Access Compliance Report

Public Rights-of-Way

(Curb Ramps)

Intersection ID: 26938	Main Street: ALEXA_RD	Cross Street: HOLLYBROOK_DR	Location: W
ADA ID: 7548605F5C98	Ramp Type: PerpDiag	Initial Pass/Fail: Fail	Overall Compliance: No
			Severity Score: 26.25

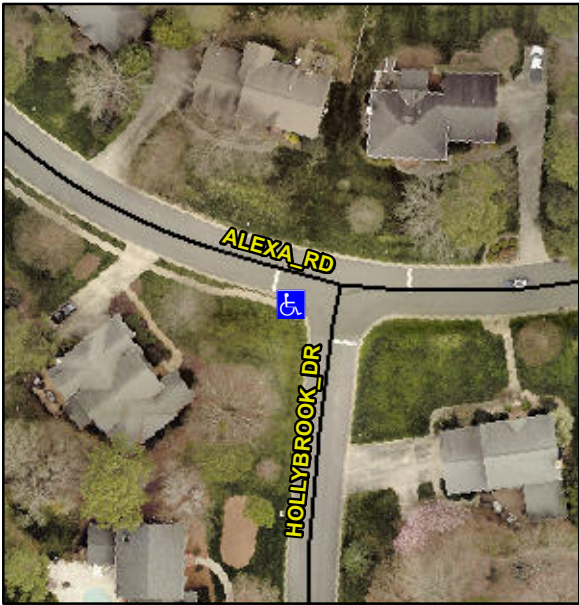
Codes/Mitigation Info/Possible Solution			Field Measurements/Component Compliance					
	Possible Solutions:		Compliance	Description	Data	Compliance	Description	Data
	Remove & Replace Curb Ramp With Two New Directional Ramps or Equivalent.		N/A	Ramp Length (in)	33.0	No	Ramp Slope (%)	12.0
			Yes	Ramp Width (in)	48.0	No	Ramp XSlope (%)	4.0
			N/A	Flare Type LT	N/A	N/A	Flare Type RT	N/A
			N/A	Flare Slope LT (%)	N/A	N/A	Flare Slope RT (%)	N/A
			N/A	Flare Traversable LT?	N/A	N/A	Flare Traversable RT?	N/A
			N/A	Landing Length (in)	N/A	N/A	DWS Provided?	N/A
			N/A	Landing Width (in)	N/A	N/A	DWS Contrast?	N/A
			N/A	Landing Slope (%)	N/A	N/A	DWS Length (in)	N/A
			N/A	Landing X Slope (%)	N/A	N/A	DWS Full Width?	N/A
Surveyor Notes:		N/A	N/A	Landing Curb? (Y/N)	N/A	N/A	DWS Offset (in)	N/A
PROW/ADA:		Not Found, R304.2.2, R304.5.3	N/A	Shared Landing?	N/A			
			N/A	Gutter Ponding?	N/A	N/A	Gutter Slope (%)	N/A
			N/A	Gutter Lip Ht (in)	N/A	N/A	Gutter X Slope (%)	N/A
